ERDC/CRREL TR-00-13

Assessment of Millennium Pipeline Project Lake Erie Crossing

Ice Scour, Sediment Sampling, and Turbidity Modeling

Prepared for
MILLENNIUM PIPELINE COMPANY

Figure 6.3. Progression of scouring ice keel-trench interaction.

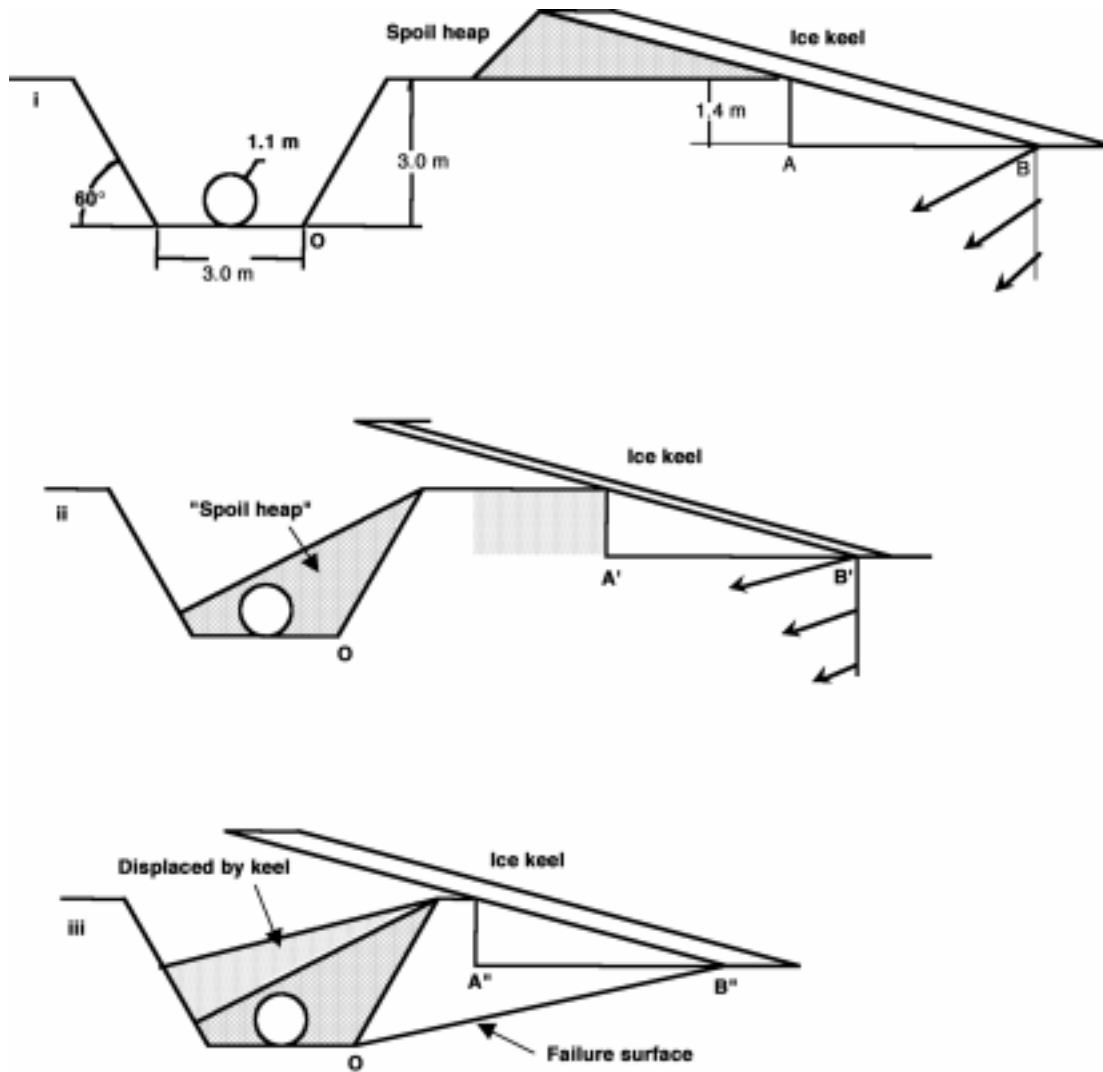
An ice keel with an attack angle of 15-degree scouring to a depth of 1.4 m (4.59 ft) and a width of 14 m (45.9 ft) is considered as shown in Figure 6.3i. This

The sub-gouge deformations are assessed from the PRISE program as shown by Woodworth-Lynas et al. (1996). The free-field sub-scour soil displacements accumulate from points A' to B' i) of Figure 6.3. The sub-scour displacement vectors are shown at three elevations under point B'. At the pipe spring-line elevation, the deformation vector magnitude is 6.2 ft. It should be noted that the free-field horizontal component is 5.1 ft, which is a very large percentage (82%) of the total deformation. This percentage increases significantly as the vertical deformation component is reduced through interaction with the trench and its infill.
